# Multilevel FDFs

IBM

# Incomplete protocol in T11/11-026v1 page 10

Figure 3 – Example of Distributed FCF with Cascaded FDFs

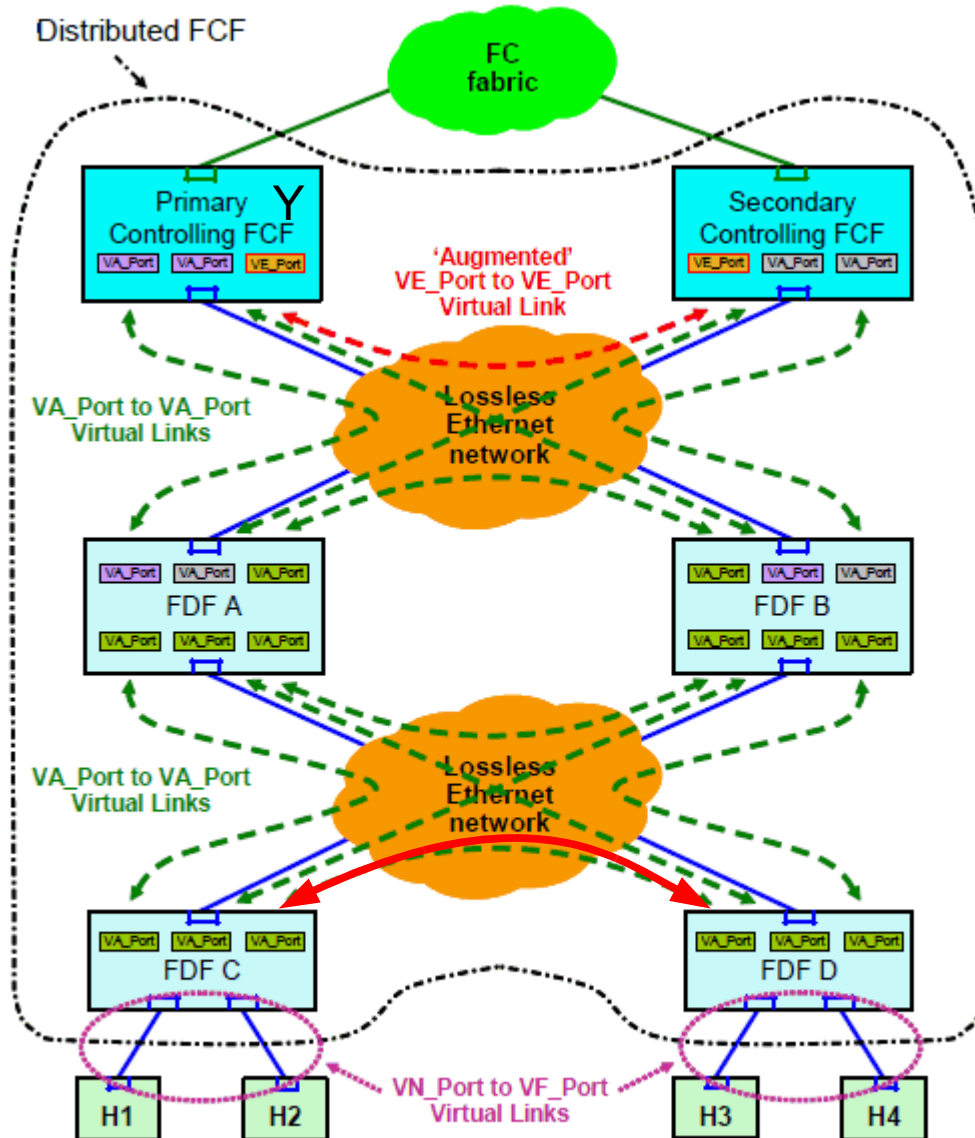
T11/11-026v1, page 10, describes the following protocol: (ignoring FDF B, NPZD, secondary controlling FCF)

- 1) FDF A/B/C/D broadcast FIP ADV
- 2) FCF Y<-> FDF A: FIP ELP exchange
- 3) FCF Y<->FDF A: DFMD with list (FDF A,B,C,D) exchange
- 4) FDF A<-> FDF C: FIP ELP exchange
- 5) FDF A<-> FDF D: FIP ELP exchange
- 6) FCF A<->FCFY: FDRN exchange, FDF A\_VA<->FDF C\_VA instantiated
- 7) FCF A<->FCFY: FDRN exchange, FDF A\_VA<->FDF D\_VA instantiated

Missing in T11/11-026v1, page 10, “Upon instantiating a VA\_Port to VA\_Port Virtual link with another...”

- 8) FCFY<->FDF C: DFMD with list (FDF A,B,C,D) exchange
- 9) FCFY<->FDF D: DFMD with list (FDF A,B,C,D) exchange
- 10) FCF C<-> FDF D: FIP ELP exchange
- 11) FCF C<->FCFY: FDRN exchange, FDF C\_VA<->FDF D\_VA instantiated

- Upon instantiating a VA\_Port to VA\_Port Virtual Link with an FDF, the primary Controlling FCF shall initiate an FDRN Exchange (see 2.3.4) describing that Virtual Link with the secondary Controlling FCF to keep the state synchronized. Upon completion of this FDRN Exchange, the primary Controlling FCF shall provide to that FDF the Distributed FCF Membership information through a DFMD Exchange (see 2.3.9). At this point the instantiated VA\_Port to VA\_Port Virtual Link becomes part of the Distributed FCF internal topology (i.e., the set of VA\_Port to VA\_Port Virtual Links internal to the Distributed FCF). The primary Controlling FCF shall recompute the N\_Port\_ID routes and distribute them to each FDF belonging to the Distributed FCF through NPRD Exchanges (see 2.3.6).

Upon instantiating a VA\_Port to VA\_Port Virtual Link with another FDF or with the secondary Controlling FCF, an FDF shall perform a FDRN Exchange with the primary Controlling FCF to inform it of the new Virtual Link. Upon completing a FDRN Exchange with an FDF, the primary Controlling FCF shall initiate another FDRN Exchange with the same parameters with the secondary Controlling FCF to keep the state synchronized. **After completing the FDRN Exchange the primary Controlling FCF shall provide to the newly reported FDF the Distributed FCF Membership information through a DFMD Exchange (see 2.3.9), if that FDF didn't not already receive a recent DFMD Exchange in a previous step. At this point the instantiated VA\_Port to VA\_Port Virtual Link becomes part of the Distributed FCF internal topology from the perspective of the newly discovered FDF (i.e., the set of VA\_Port to VA\_Port Virtual Links internal to the Distributed FCF). Upon completion of this ~~FDRN~~DFMD Exchange, the primary Controlling FCF shall recompute the N\_Port\_ID routes and distribute them to each FDF belonging to the Distributed FCF through NPRD Exchanges.**
